STATE OF NORTH CAROLINA
DEPARTMENT OF TRANSPORTATION

Addendum No. 1
RE: Contract # C204039
WBS # 34243.3.2
STATE FUNDED
Polk County (I-4729A)
I-26/US-74/NC-108 Interchange Modifications in the Town Of Columbus

September 19, 2017 Letting

The following revisions have been made to the Roadway plans:

14-AUG-2017 08:18
J:\14-4729A\Design\XSC\I-4729A_Rdy_xpl.dgn
$$$$USERNAME$$$$

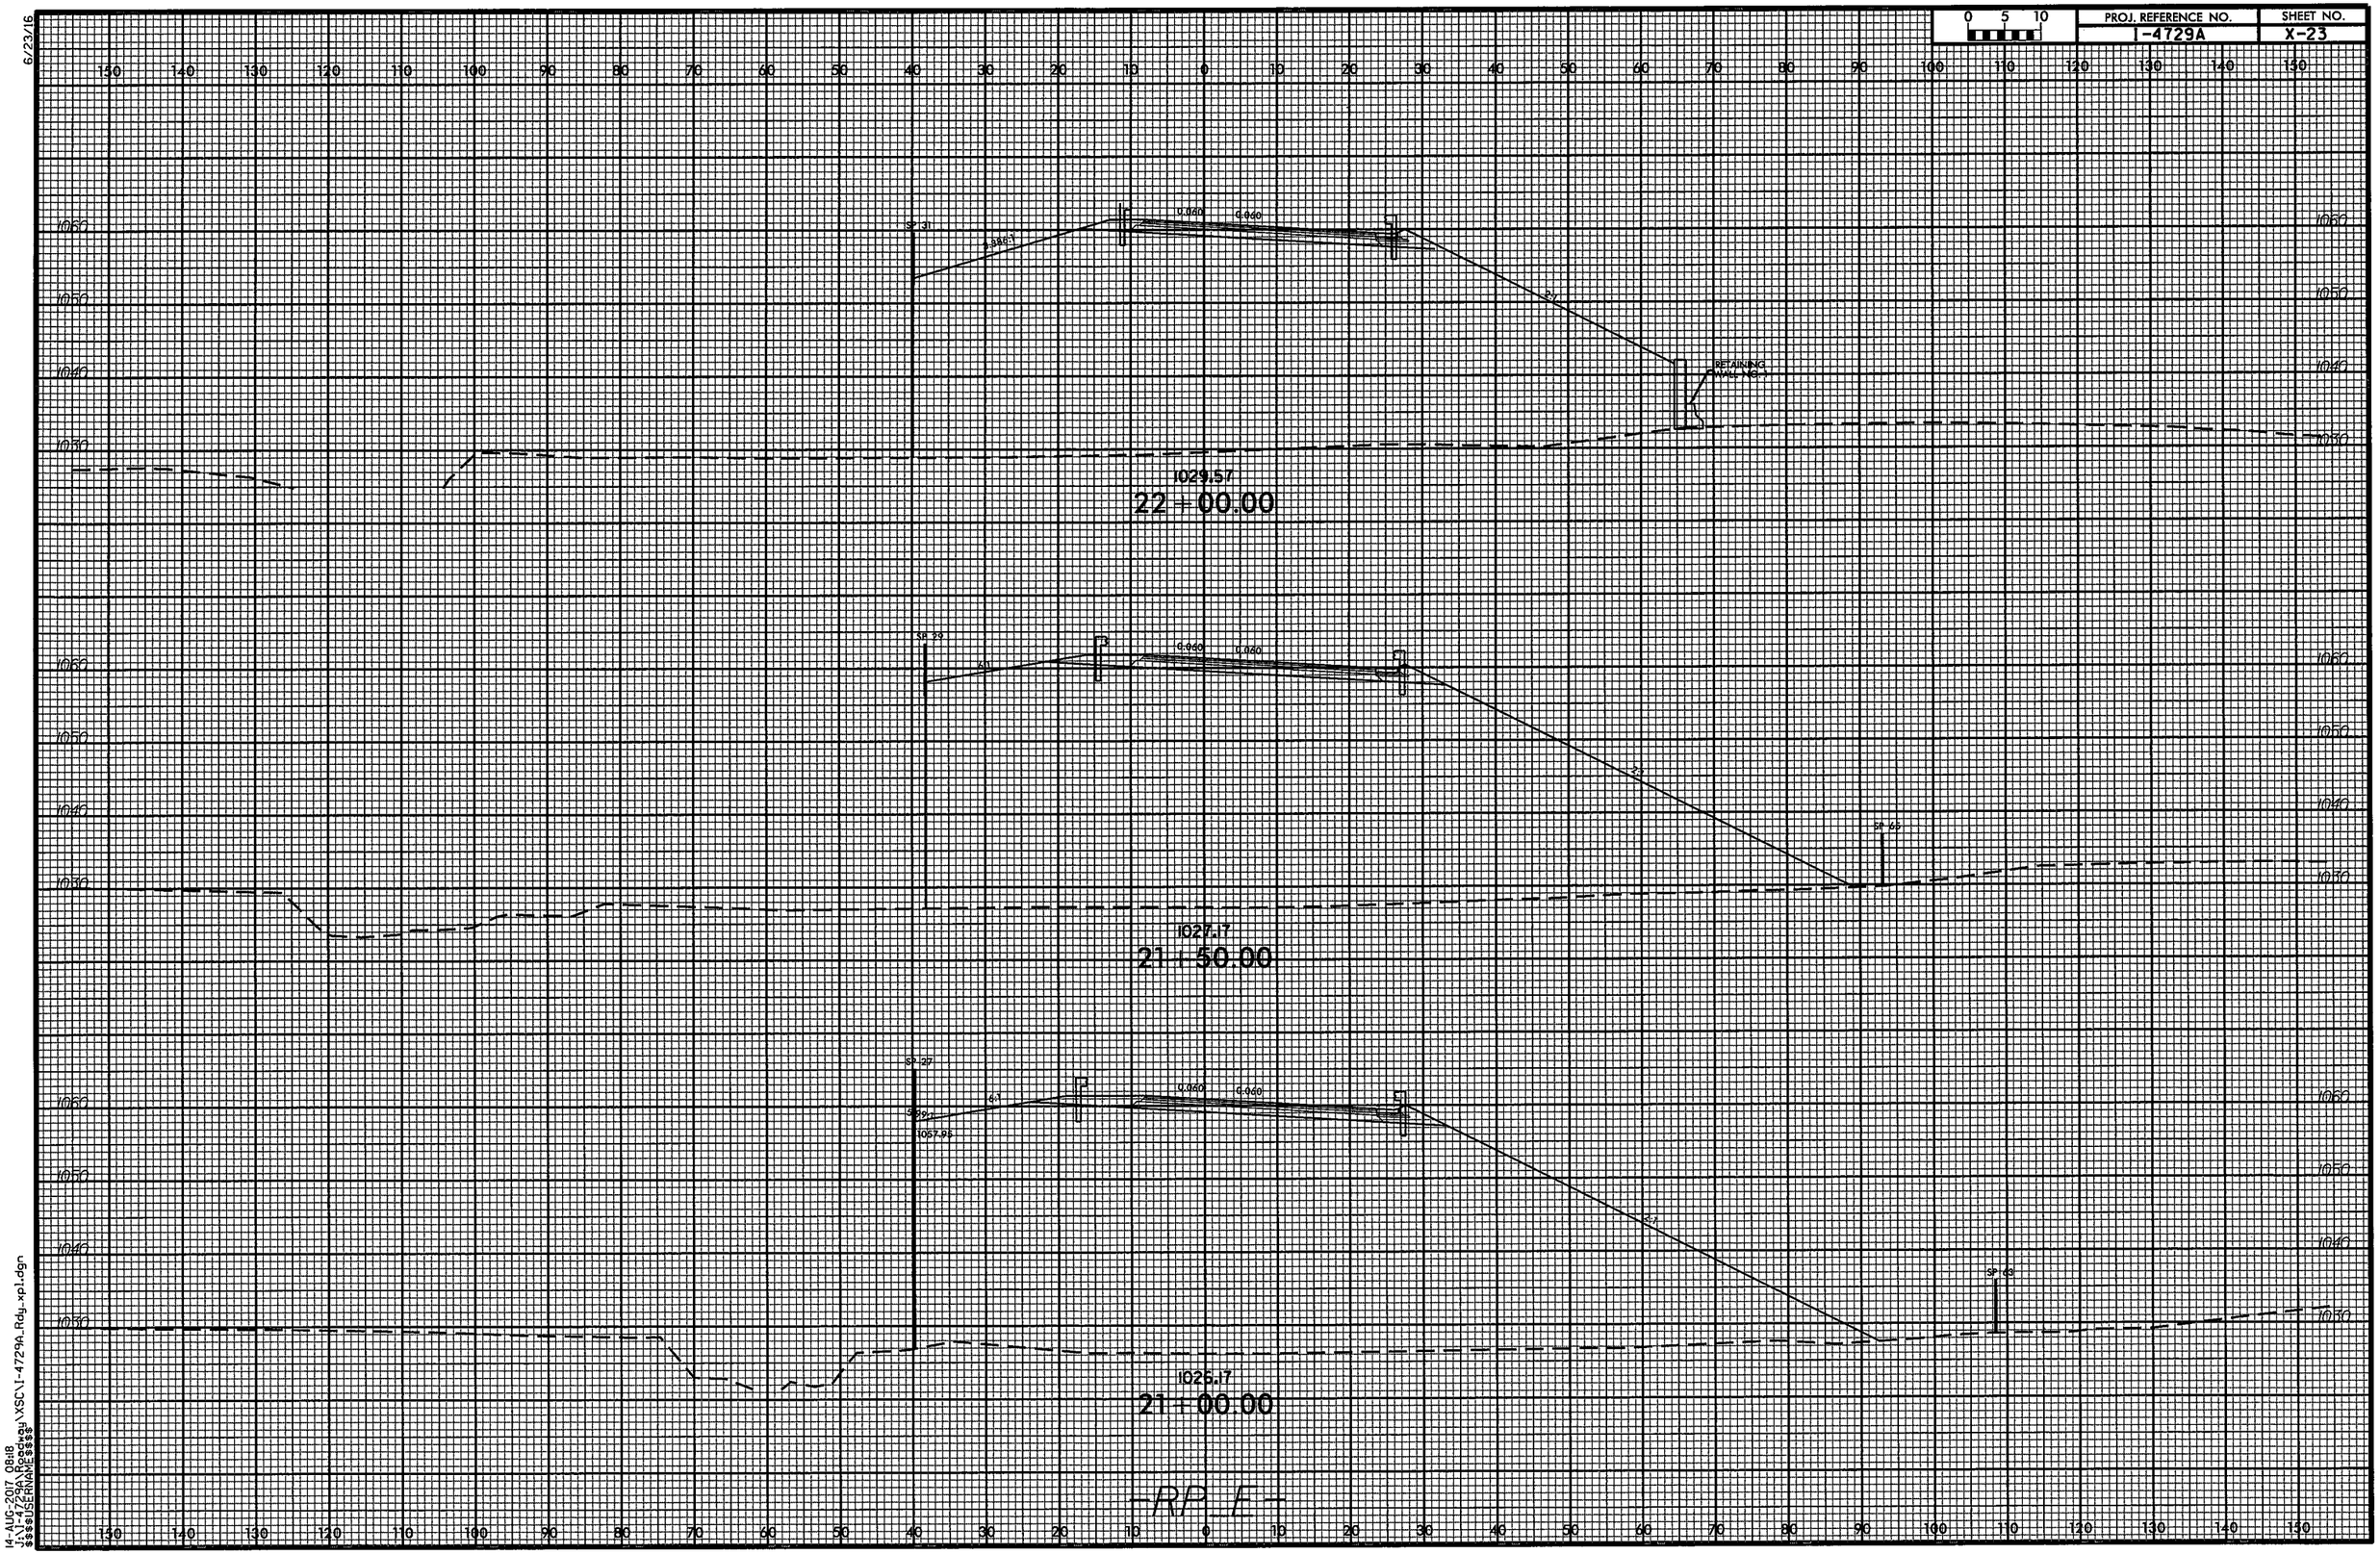
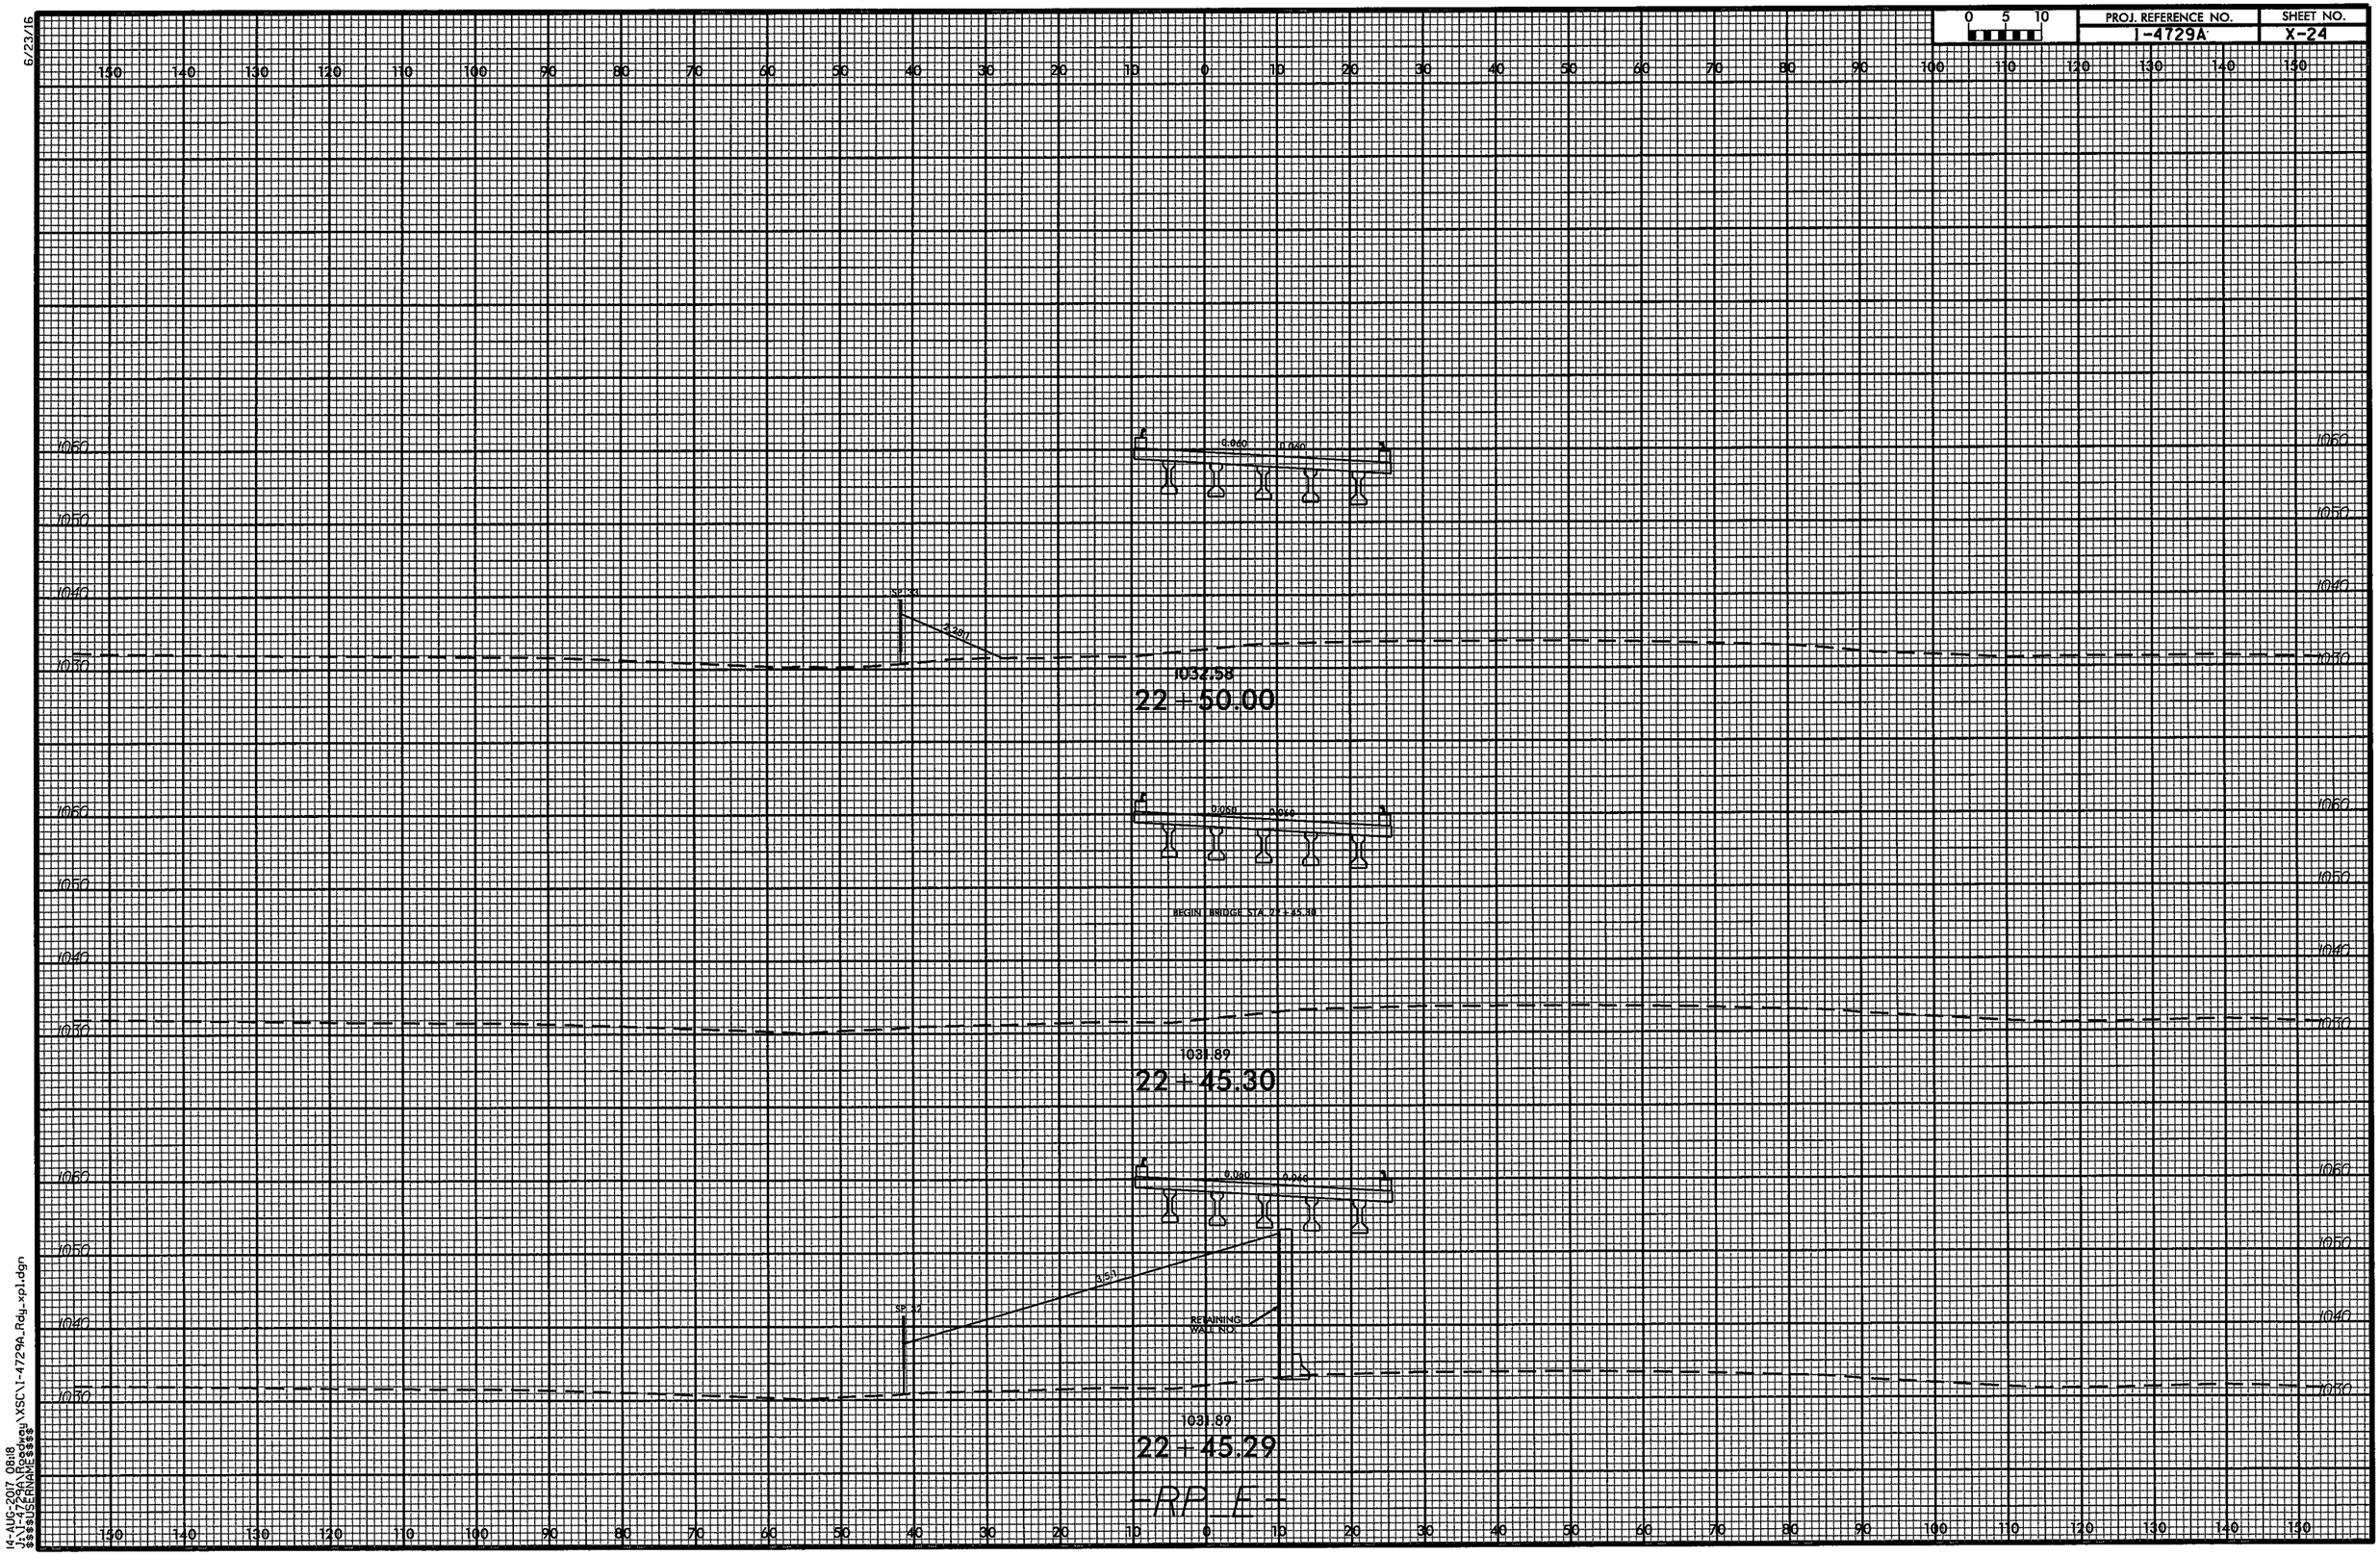
Sheet No.	Revisions
1A	Revised Index of Sheets to remove 2G-2 "Standard Embankment Monitoring Detail" and revise the number of" Drainage Summaries" sheets
2A-1, 2A-4 and 2A-5	Revised the Typical Sections for the change in mainline pavement widening design from ABC to Asphalt Base
3B-1	Revised 'Summary of Earthwork' to account for pavement widening design change
3D-1 thru 3D-4	Various drainage quantity changes as noted below
3G-1	Removed "Settlement Gauge Summary" and added note that Bridge Waiting Period only applies to Approach Slab construction
5	Revised to require Welded Steel Pipe by Trenchless method under the Interstate 26
X-1A thru X-87	Revised Cross-Sections to reflect the change in Earthwork due to the pavement design change
